Job No. 192628

July 13, 2023  
Revised May 3, 2024

Re: Wastewater Study  
Meadow Lake Industrial  
Section 9, Township 15 South, Range 65 West  
El Paso County, Colorado

**PROPOSED SITE PLAN**

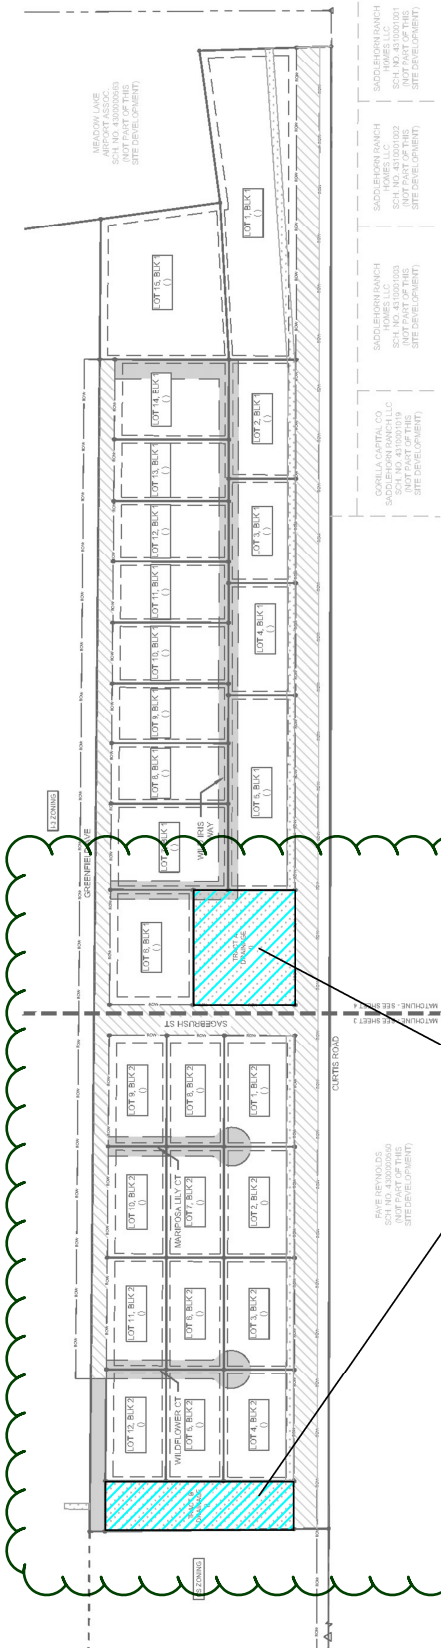
This is in conflict with all other documents (and other maps within this report), which allocates these as as dedicated drainage tracts for stormwater ponds and as such, cannot contain OWTS

This is inaccurate. These drainage tracts are set for the proposed water quality ponds. Read ECM Section 1.7.6 for separation distance requirements between water quality facilities and OWTS systems.
